Nebraska Responses to Federal Land Manager (FLM) Comments on Nebraska's Draft Regional Haze (RH) Progress Report for the Second Implementation Period (2018-2028)

FLM Comments are summarized below in black print – please see Attachments 1.b. 1.b.1., and 1.b.2. for the complete comments and supporting documentation received from Federal Land Managers. Nebraska Department of Water, Energy, and Environment (DWEE) responses are in blue italics.

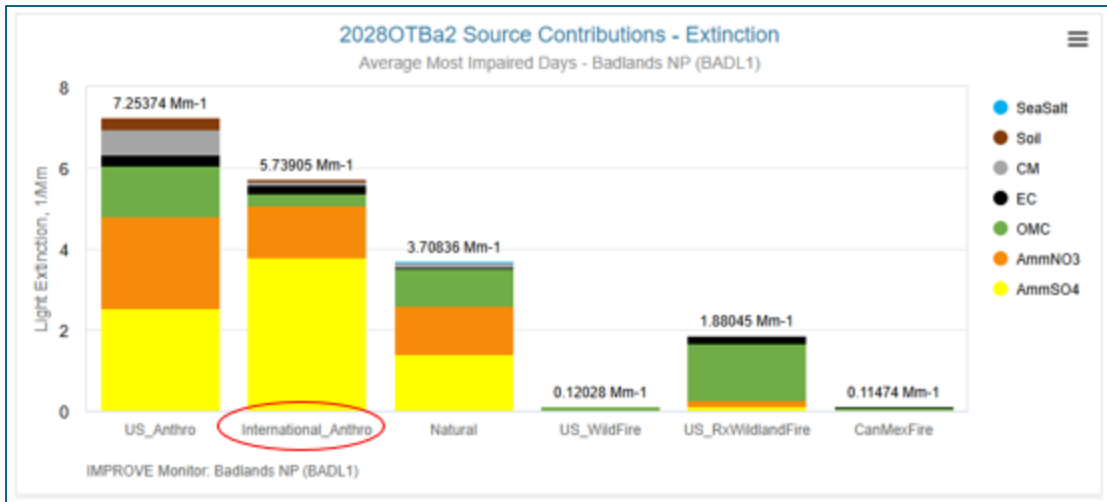
Figures 2 and 3, which present deciview trends at Badlands and Wind Cave National Parks, show that deciview values on the most impaired days increased over the period 2020-2023. However, on page 18, the progress report concludes that:

Given that the most recent four-year period shows deciview increases on the most impaired days, why does the report conclude that current plan elements and strategies are sufficient to enable South Dakota to meet its reasonable progress goals?

Despite recent deciview increases, visibility conditions remain below the adjusted glidepath used by South Dakota for the second period. The adjusted glidepath (2028OTBa2 EPA Projection w/international + wildland rx fire endpoint) accounts for international anthropogenic emissions and wildland prescribed fire; EPA has proposed¹⁰ to approve the State’s use of this glidepath.

When examining modeled impacts on visibility conditions at the SD Class I areas, significant visibility impacts are attributed to the International Anthropogenic and U.S. Wildland Prescribed Fire source categories.
